City of Richmond
Urban Development Division

Report to Development Permit Panel

To: Development Permit Panel
From: Joe Erceg
Manager, Development Applications
Date: November 19, 2003
File: DP 03-233036
Re: **Application by Dava Developments Ltd. for a Development Permit at
7060 Bridge Street**

SKETCH OF SITE PLAN TO PRESERVE EXISTING TREES / OPEN SPACE

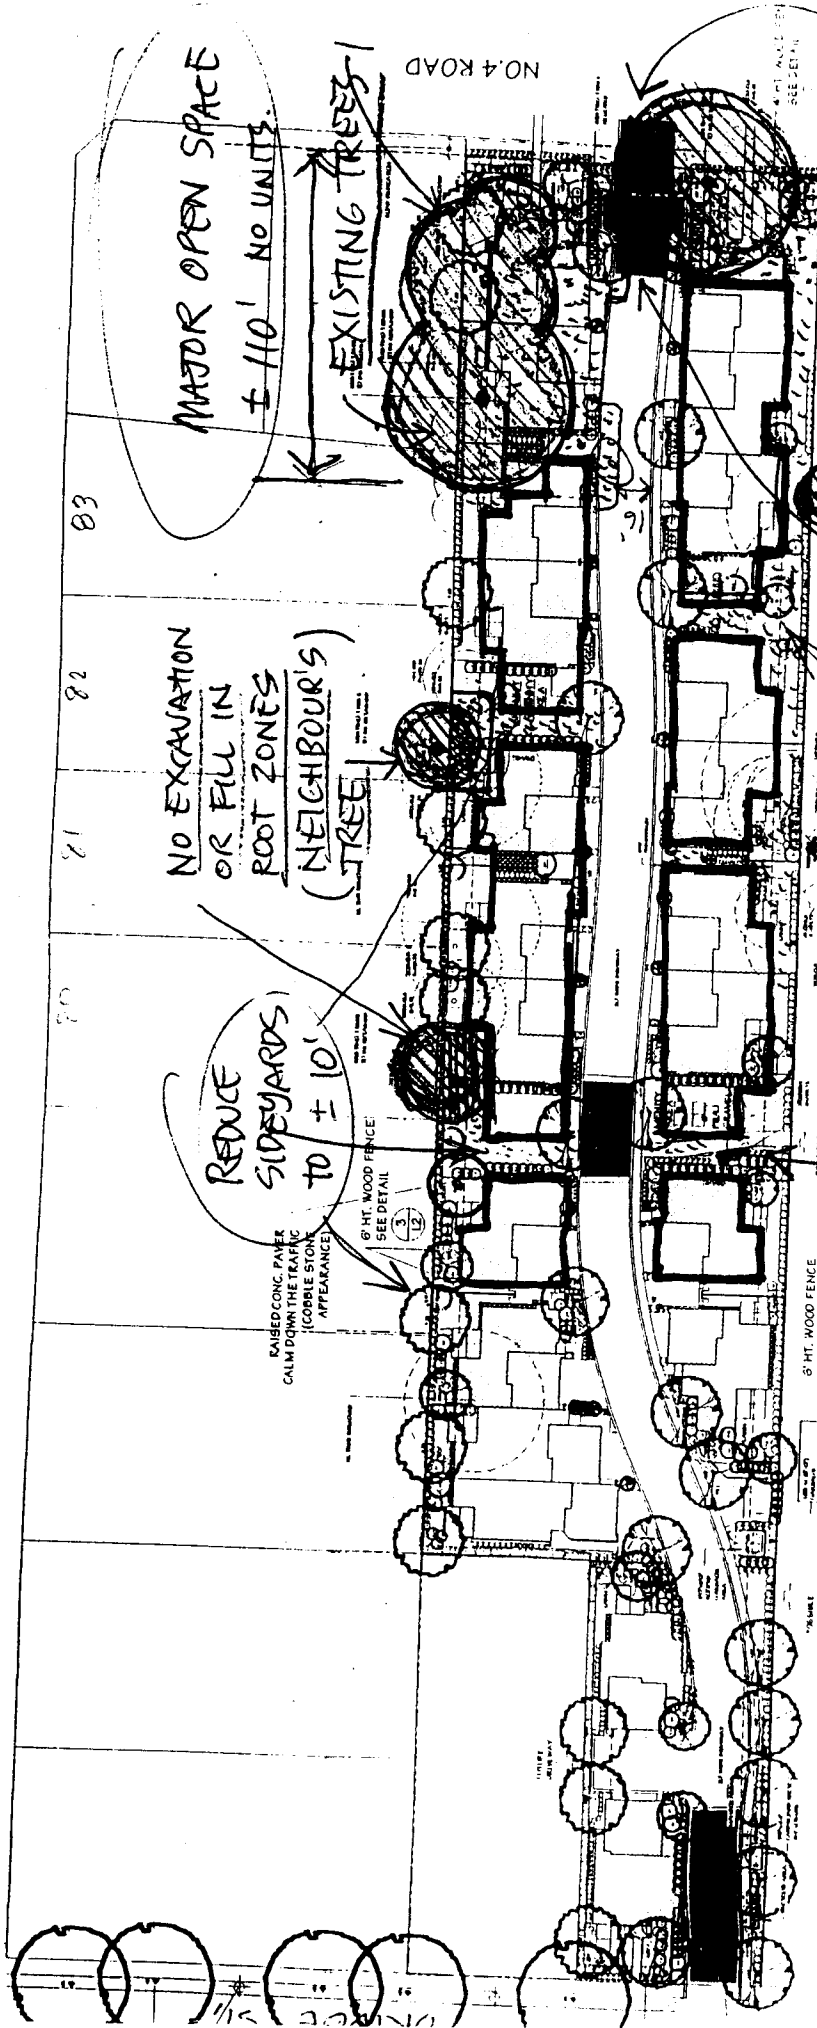
Open spaces should be rearranged to take better advantage of remaining six trees. The conifers and large Rhododendron in the north-east corner of the site should be preserved in an open space and an open space should be moved to centre/south perimeter where there is an existing cluster of trees. (See attached sketch plan). ***The applicant has only agreed to retain two trees; by shifting the units slightly to the west. The Rhododendron was stolen from the site. (Staff note that there is no protective fencing around the existing trees).***

Staff feel that there is an opportunity to further redesign the site plan to not only preserve more existing trees, but to make a larger and more functional open space (see attached sketch). A less drastic change which would still require some redesign would be to retain the single unit (building #4) and adjacent open space as per the neighbour's wishes, and also to retain the large trees and some open space near No. 4 Road, but this would probably result in one or two less units. If necessary, the floor area ratio (FAR) could be regained by making some of the remaining units larger. It should be noted that several other developers in McLennan South have made significant compromises to preserve mature trees.

- **Option 1.** The plan arrived at during the rezoning stage (this option is favoured by the applicant and is incorporated into the present set of plans), and
- **Option 2.** This option attempts to preserve more trees and consolidate the open space near #4 Road. The plan was formulated during the development permit process. (see sketch attached).

OMIT HAMMER-HEAD - REDUCE DRIVEWAY TO 16'

REDUCE PAYEMENT TO TWO TIRE-STRIP - EMERGENCY ACCESS ONLY,

REDUCE SIDEYARDS TO ± 10'

MAJOR OPEN SPACE ± 110' NO UNITS
